Manitoba Public Utilities Board

Manitoba Hydro NFAT IEC Transmission Line Construction and Management Report – Public Version

PREPARED FOR: MANITOBA PUBLIC UTILITIES BOARD
PREPARED BY: POWER ENGINEERS, INC.

Figure 1: Keeyask Transmission Project

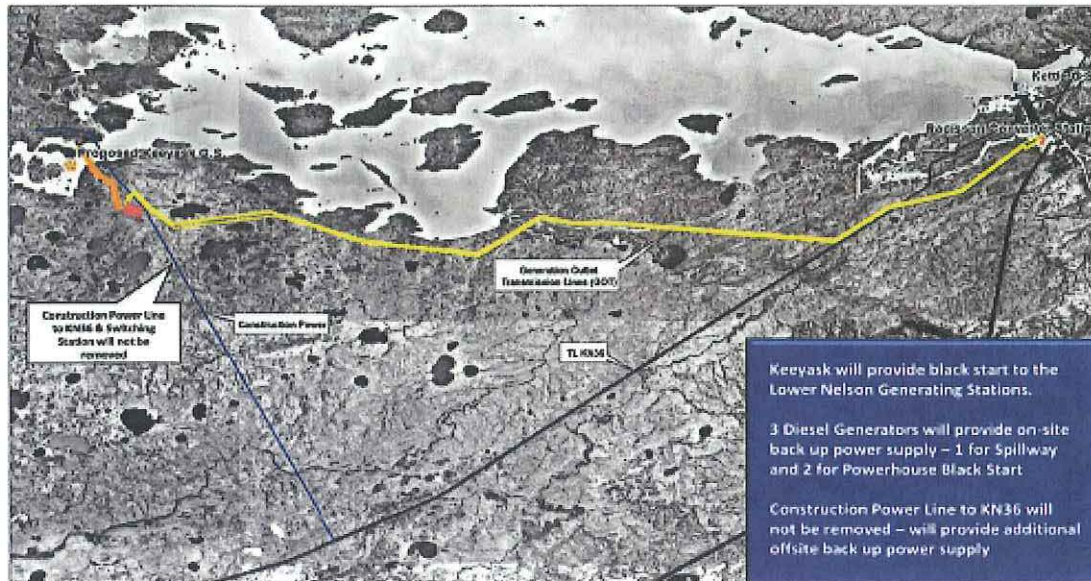
In 2012 Dollars, the estimate for the Generator outlet lines and Unit lines (KR1, KR2, & KR3) totaling 110 km in length amounts to \$727,272/km. We questioned this amount as being excessively high, even taking into account winter construction. A telephone conversation [C, pg 58] on December 11, 2013 with Joel Wortley provided answers that we can accept.

- a. The project is very short and efficiencies of longer lines cannot be obtained.
- b. The project requires 2 mobilizations because it is constructed in two different years.
- c. The river crossing is difficult and expensive.

These are valid reasons for increasing estimated costs. Without these mitigating factors POWER would estimate the cost of a similar 138 kV line at about \$639,000/km [E, pg 66]. The area, climatologic conditions and the multiple mobilizations all contribute to costs that can be much higher than a line without these constraints. Allowing a 15% added cost for short projects, an extra \$250,000 for the second mobilization in 2019, and a river crossing cost adder of \$100,000 per line, produces an estimate of about \$97,018,000 for the project in 2012 Dollars, (738,000/km). Our estimate and MH's estimate fall within 5%, which we consider to be an acceptable range.

Figure 2: Conawapa Transmission Project

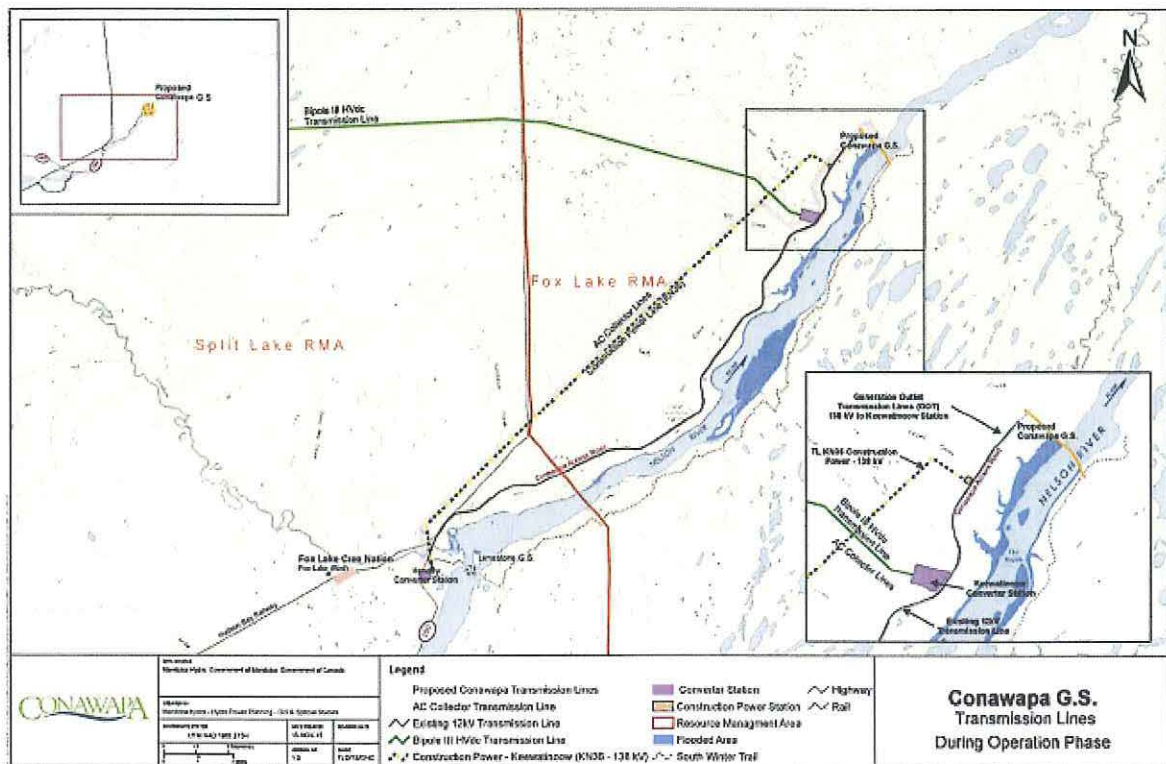
The MH per-km cost estimate for the 230 kV lines in 2012 Dollars is \$286,000/km. (\$10 million/35 km)

POWER Engineers prepared an estimate for a similar 230 kV line in similar ground conditions and made adjustments for winter construction [E, pg 70]. We included the structure information provided by MH, and made adjustments based on the ground conditions. Our estimate in 2013 Dollars is \$344,000/km with an expected accuracy of $\pm 20\%$. The estimates provided in the NFAT filing fall at the very low range of our expected cost for 230 kV line construction in similar terrain.
